# INSPECTION REPORT

**Property Address:** 1716 COPPER RIDGE SPUR, UNIT:C1;

**To construct:** New Duplex style Live Work Unit 1

On this day we have inspected your construction for **Final Planning Department Site Improvement** and we find the following result of the inspection. If there are any questions, please call the inspector at the address below.

**SITE PLAN**

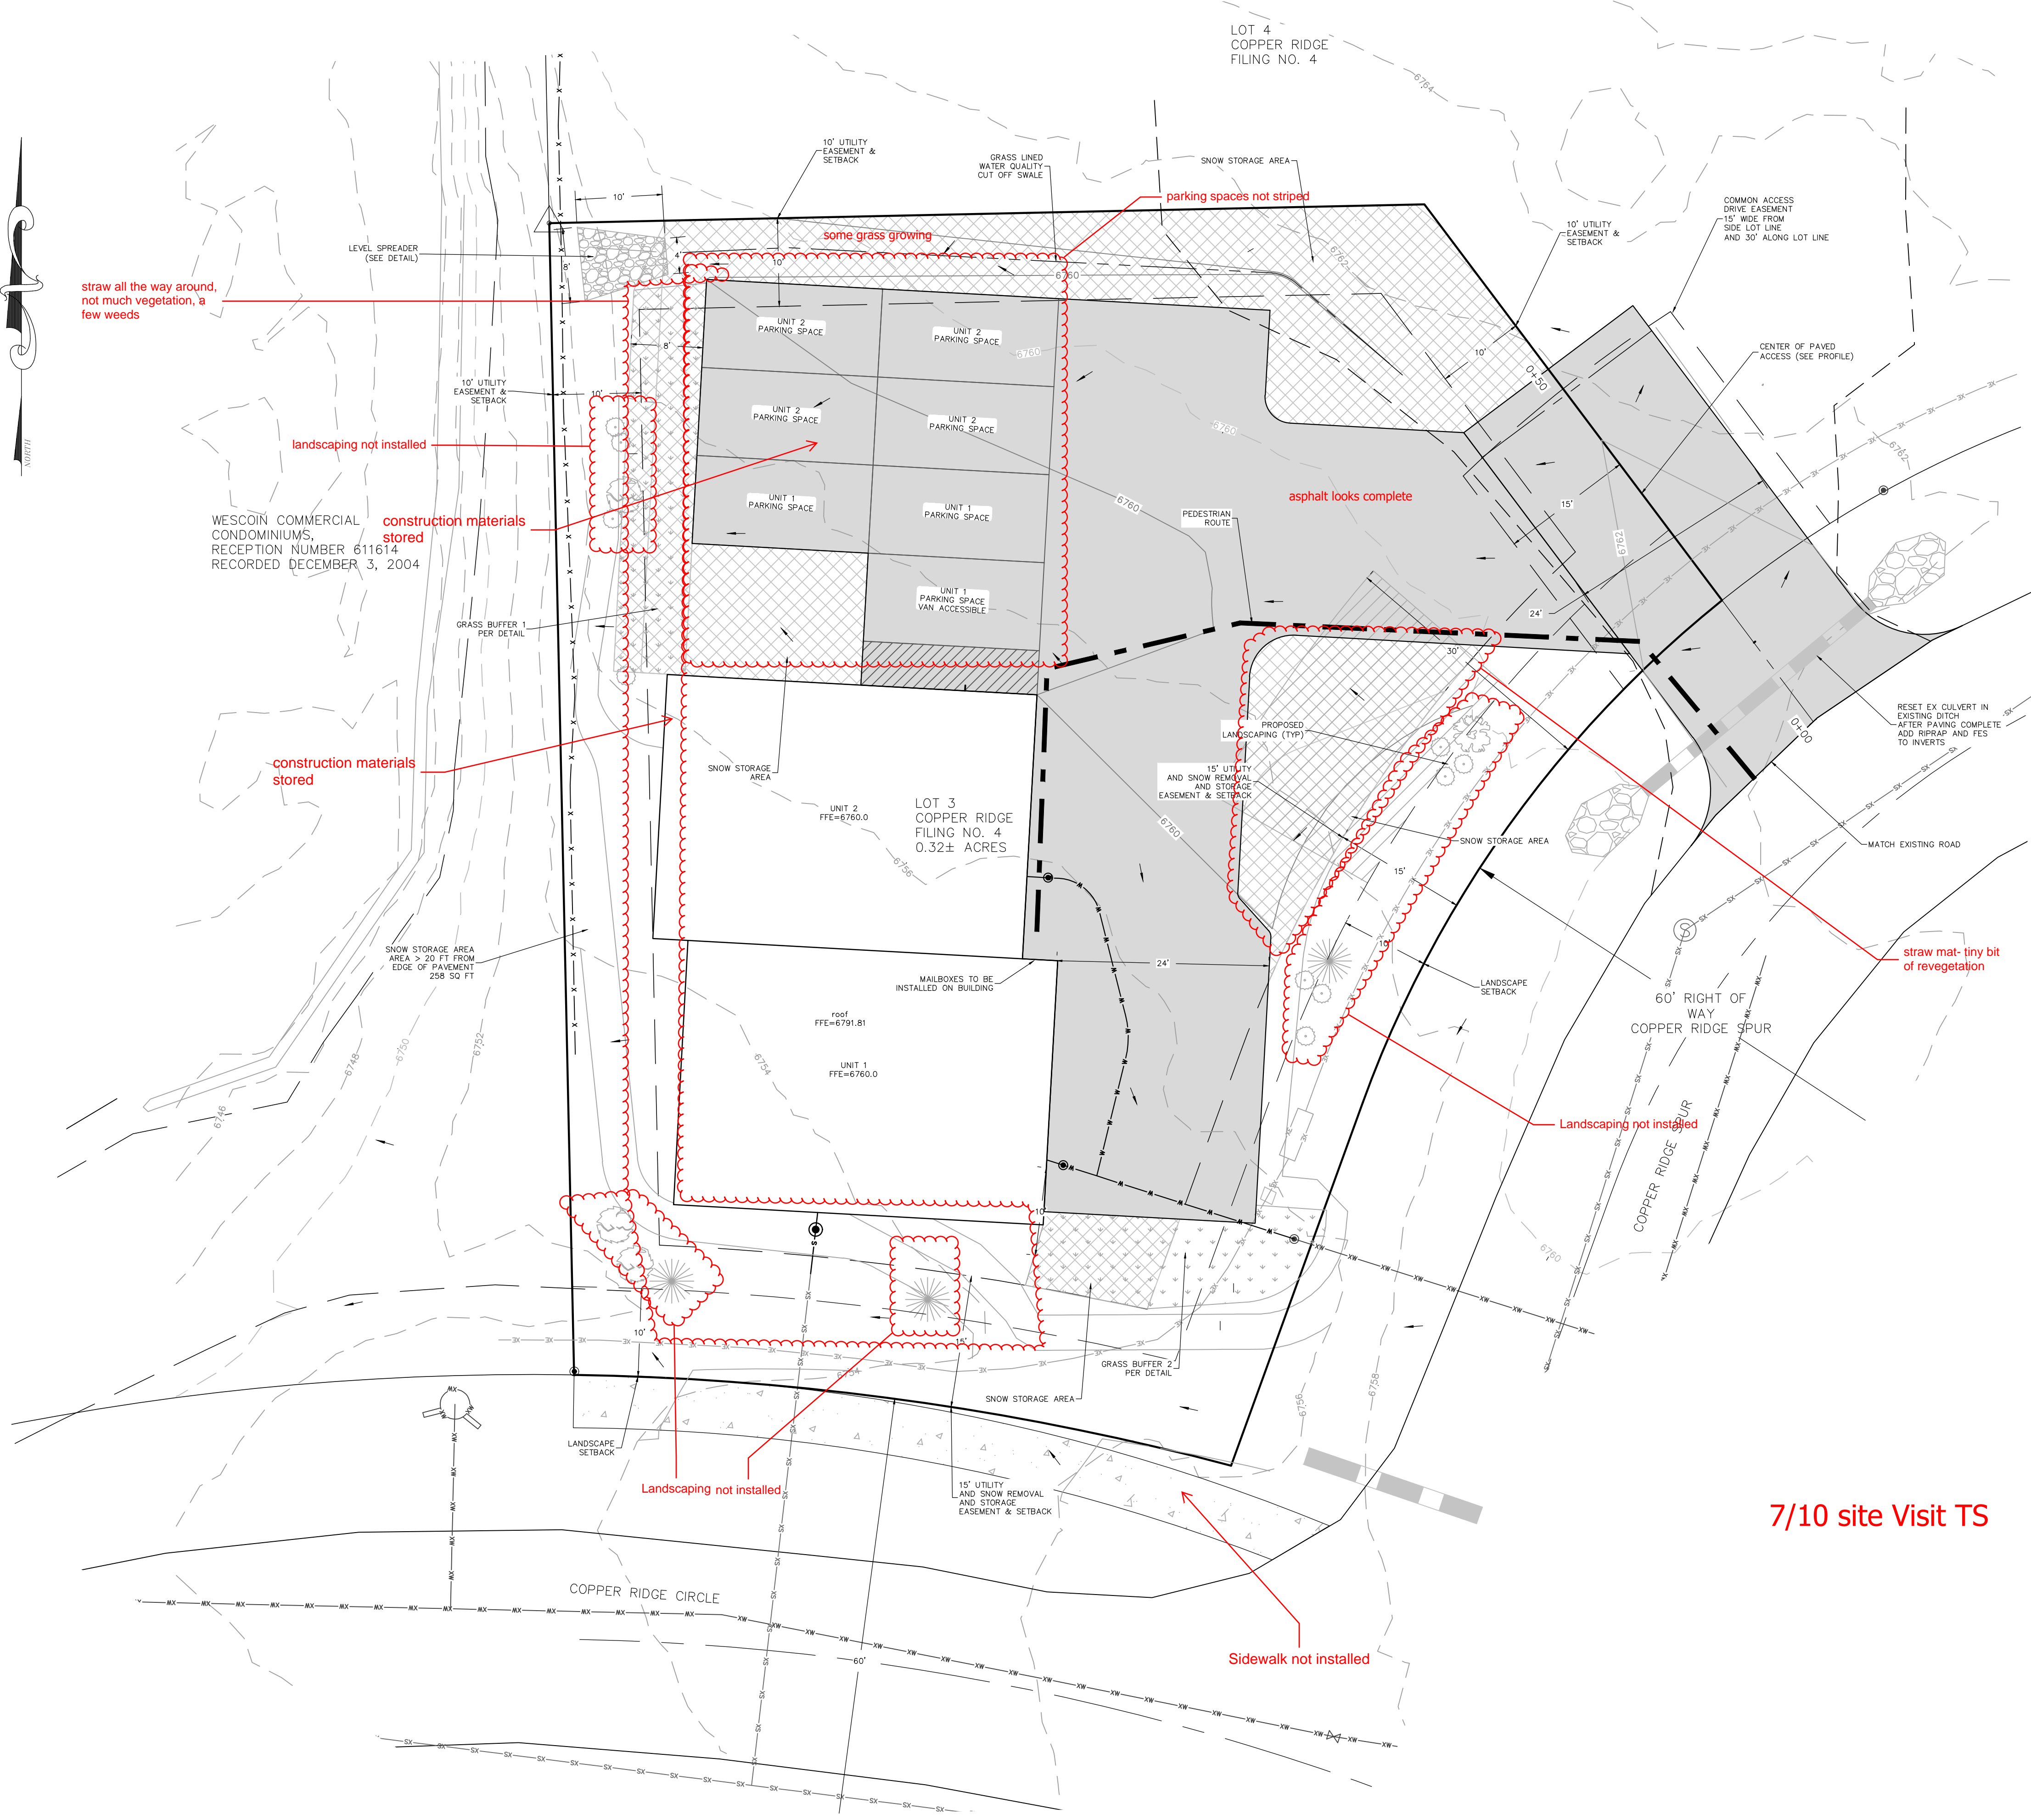
- 1 See Document Markups
- 2 Critical improvements are incomplete, see conditions on PL20220235

7/10 site Visit TS
